SUBJECT: NORTH ANNA UNITS 1 AND 2 - ISSUANCE OF AMENDMENTS RE: CONTAINMENT
UPPER LIMIT TEMPERATURE (TAC NOS. 67535 AND 67536)

The amendments revise the NA-1&2 TS containment air temperature upper limit from 105°F to 120°F and the volume of water available from the refueling water storage tank for the quench spray system is redefined and reduced to permit the use of wide range level instrumentation for TS surveillance.

Amendment No. 110
License No. NPF-4

Amendment No. 96
License No. NPF-7

Figure 3.6-1

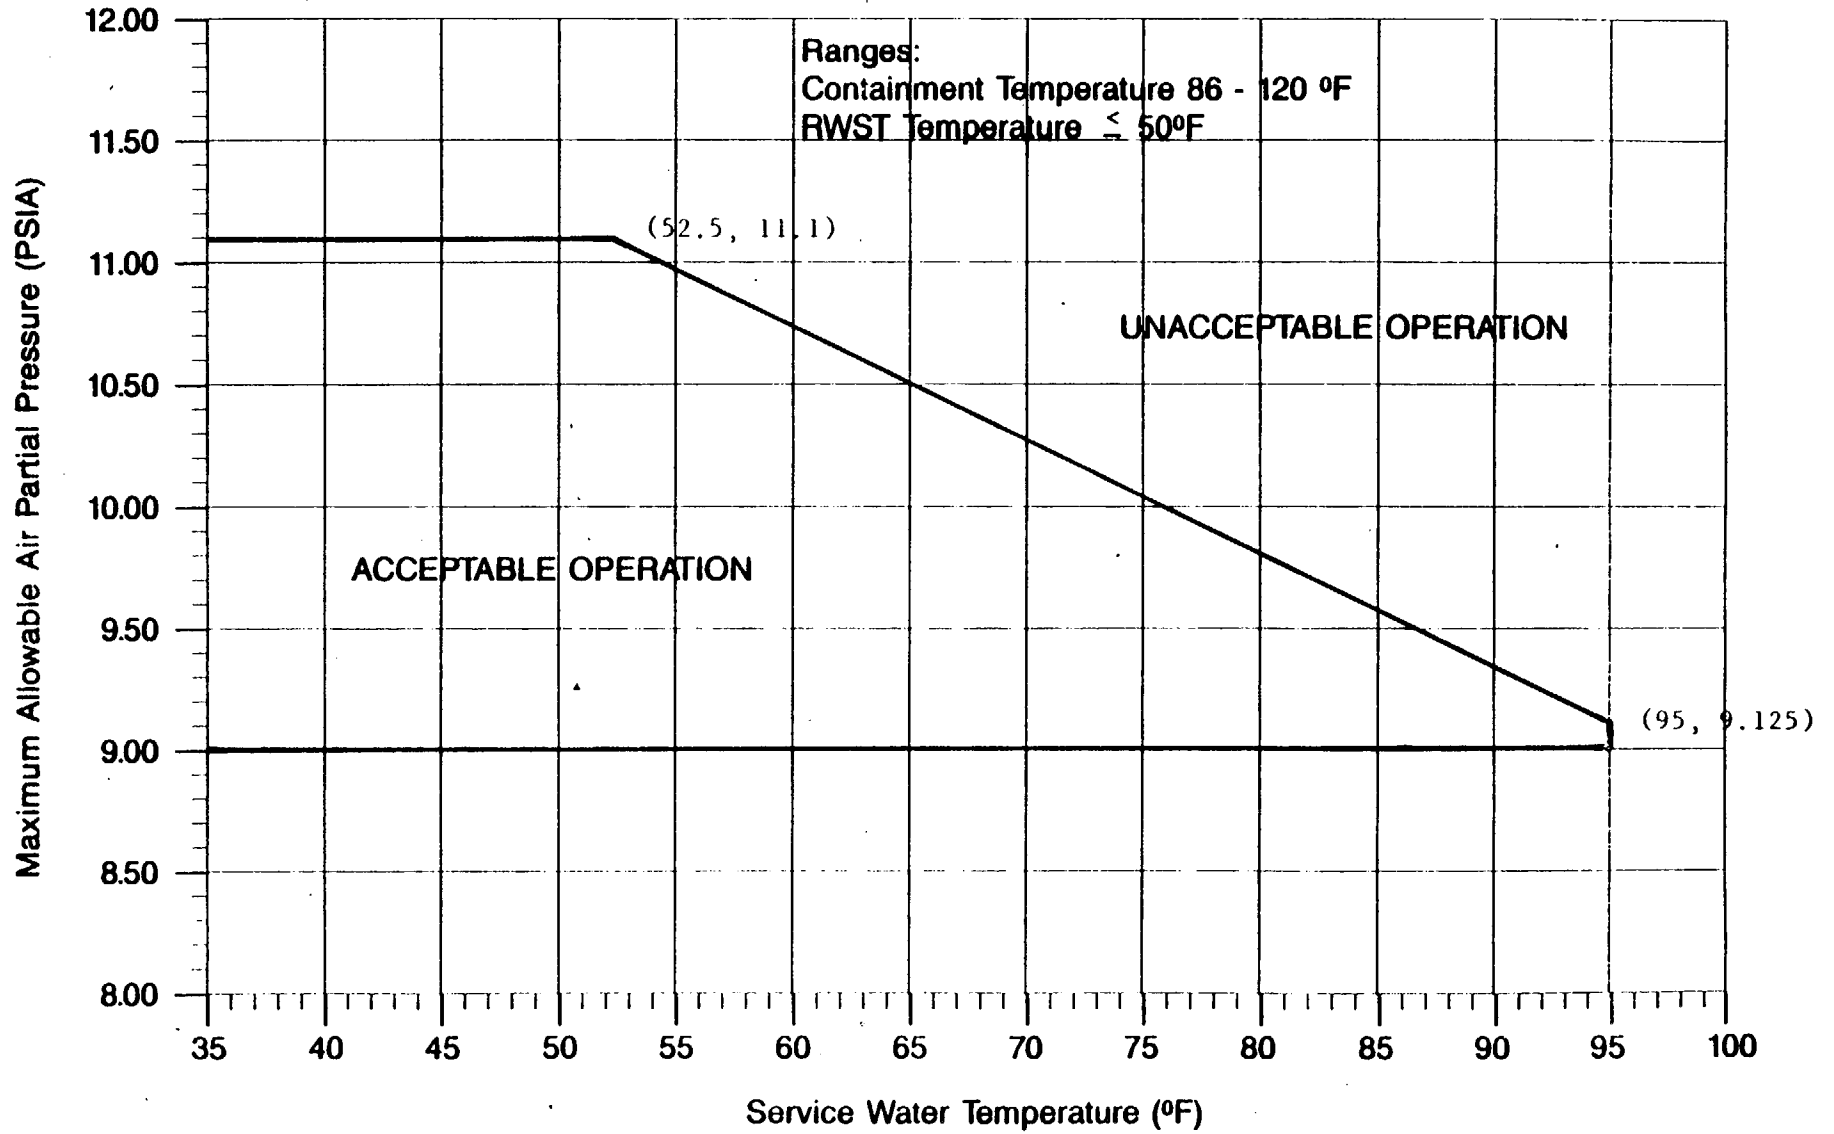
3.6.1.4 Primary containment internal air partial pressure shall be maintained > 9.0 psia and within the acceptable operation region on Figure 3.6-1.

With the containment internal air partial pressure < 9.0 psia or above the applicable limit shown on Figure 3.6-1, restore the internal air partial pressure to within the limits within 1 hour or be in at least HOT STANDBY within the next 6 hours and in COLD SHUTDOWN within the following 30 hours.

The limits shown in Figure 3.6-1 and Specification 3.6.1.5 are consistent with the assumptions of the accident analyses which included consideration of instrument loop uncertainties.

The containment internal air partial pressure limit has been revised based on the analytical results justifying operation at the increased containment temperature. The minimum limit is set by the structural criteria for the containment mat. The revised diagonal limit line in TS Figure 3.6-1 is set by the LOCA depressurization analysis. The MSLB analysis sets the horizontal limit line at 11.1 psia. All of the limit lines have been conservatively changed to reflect the containment vacuum and leakage monitoring pressure instrumentation loop uncertainty which is used by the operator for periodic surveillance.

Figure 3.6-1

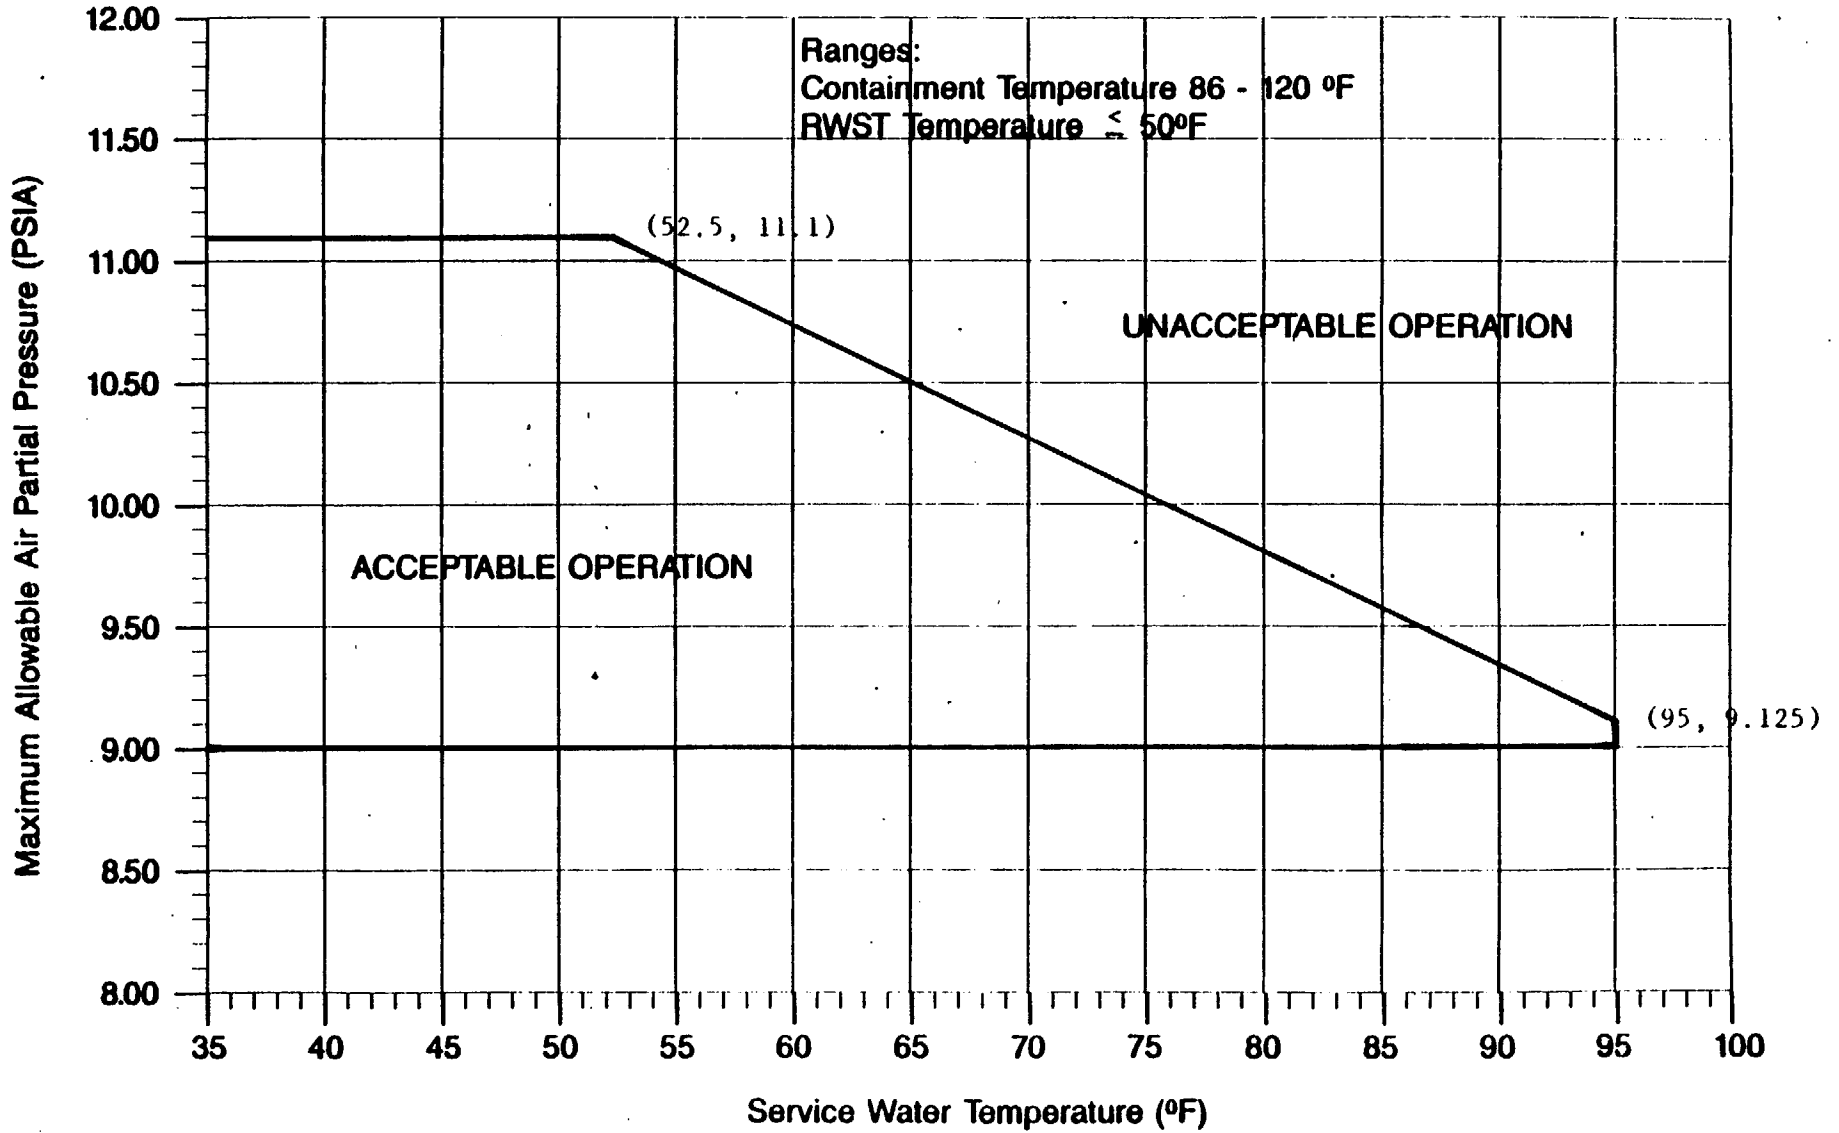
3.6.1.4 Primary containment internal air partial pressure shall be maintained greater than or equal to 9.0 psia and within the acceptable operation on Figure 3.6-1.

With the containment internal air partial pressure less than 9.0 psia or above the applicable limit shown on Figure 3.6-1, restore the internal air partial pressure to within the limits within 1 hour or be in at least HOT STANDBY within the next 6 hours and in COLD SHUTDOWN within the following 30 hours.

The limits shown in Figure 3.6-1 and Specification 3.6.1.5 are consistent with the assumptions of the accident analyses which included consideration of instrument loop uncertainties.
